FILE NO.: HDC2025-005

NAME: 1420 Commerce Street - Certificate of Appropriateness

A. PROPOSAL/REQUEST/APPLICANT’S STATEMENT:

The application seeks retroactive approval for the installation of two skylights, front porch handrail, and front porch lighting. Additionally, the application proposes the installation of rear yard privacy fencing.

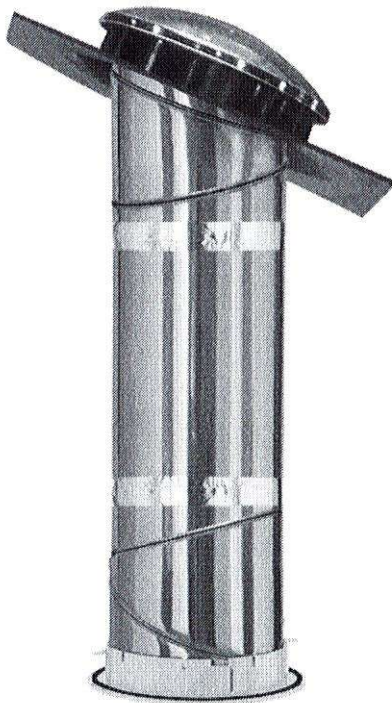
The application proposes to install two skylights near and one the south gable end, one rectangular-shaped skylight on the south-facing roof slope and one tubular skylight on the west-facing side gable roof slope. Both skylights are located on roof slopes that are minimally visible from public right-of-way. The south-facing skylight is aluminum and 21 inches x 45 ³/₄ inches with laminated low-E3 glass. The west-facing skylight is acrylic and 10 inches in diameter, with an elevated profile. The skylights bring light into the attic space that has been converted into a half-story loft.

Staff finds the installation of the two skylights to be consistent with the *Design Guidelines*, specifically Guideline 4.26(9). The proposed roof alterations do not alter the front façade and do not destroy historic materials, features, or spatial relationships that characterize the property. The roof alterations are differentiated and compatible with the historic roof form and do not threaten the structure’s historic integrity.
